SUBJECT: SURRY UNITS 1 AND 2 - ISSUANCE OF AMENDMENTS RE: CONTAINMENT ISOLATION (TAC NOS. M83768 AND M83769)

AMENDMENT NO. 172 TO FACILITY OPERATING LICENSE NO. DPR-32 - SURRY UNIT 1  
AMENDMENT NO. 171 TO FACILITY OPERATING LICENSE NO. DPR-37 - SURRY UNIT 2

SAFETY EVALUATION BY THE OFFICE OF NUCLEAR REACTOR REGULATION  
RELATED TO AMENDMENT NO. 172 TO FACILITY OPERATING LICENSE NO. DPR-32  
AND AMENDMENT NO. 171 TO FACILITY OPERATING LICENSE NO. DPR-37  
VIRGINIA ELECTRIC AND POWER COMPANY  
SURRY POWER STATION, UNIT NOS. 1 AND 2  
DOCKET NOS. 50-280 AND 50-281

**ALLOWABLE AIR PARTIAL PRESSURE  
SURRY POWER STATION UNITS 1 AND 2**

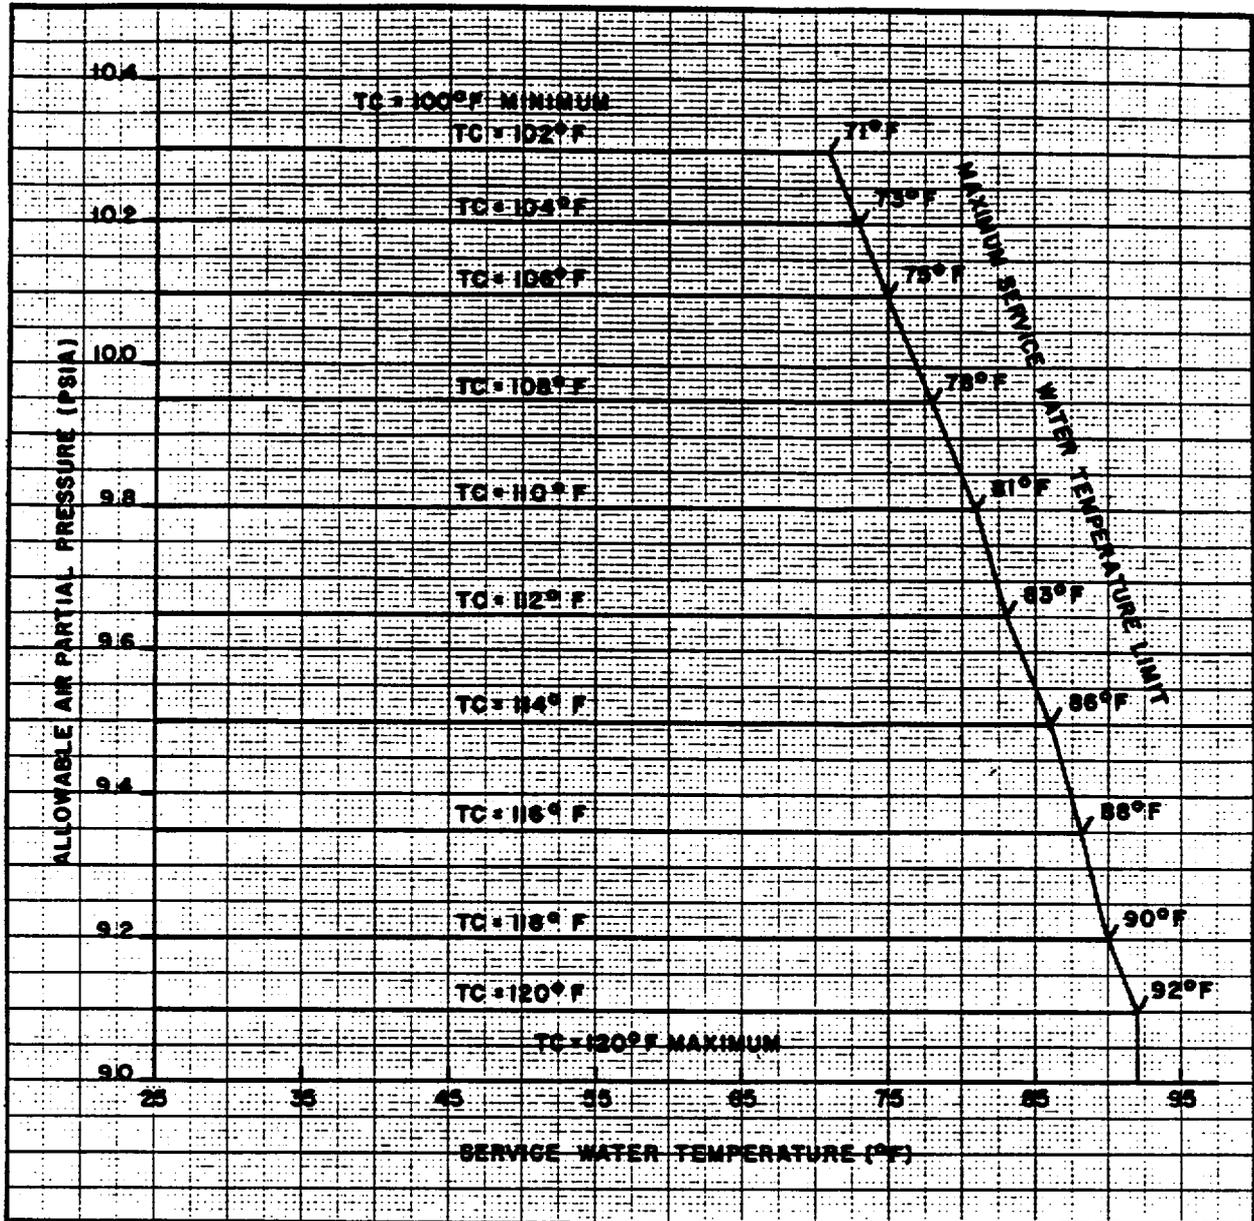
1. The notes in Figure 3.8-1 that are also specified in the body of TS 3.8 are being deleted to avoid possible confusion with other redundant requirements.

**FIGURE NOTATION**

TC - Containment average temperature

**FIGURE NOTES**

1. Refueling Water Storage Tank temperature  $\leq 45^{\circ}\text{F}$ .
2. Allowable operating air partial pressure in the containment is a function of service water temperature.
3. Horizontal lines designate allowable air partial pressure per given containment average temperature.
4. Each containment temperature line is a maximum for the given air partial pressure.
